URBAN DESIGN ASSESSMENT AND PEER REVIEW REPORT

RESOURCE CONSENT APPLICATION GULL SERVICE STATION N, POKENO

PSP NUMBER	PSP18-195	HG PROJECT NUMBER	1021-145623-02
PROJECT AND LOCATION	To construct a 24 hour self-service petrol station at 72 Great South Road, Pokeno.	DATE	2 December 2020
REPORT NAME	Urban Design Assessment Report	STATUS	Final
PREPARED BY	Sam Coles – Senior Urban Designer

Below: Gull Kaukapapa showing retail, signage and canopy:

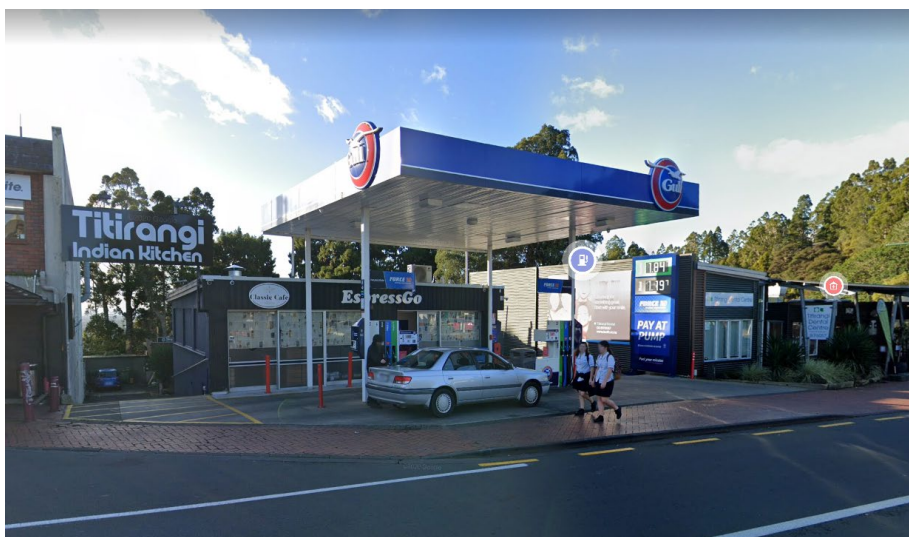
Recommendations for mitigation measures are intended to be broadly in line with the design outcomes exhibited by other service stations, including Gull sites; the following photographs demonstrate some of these measures:
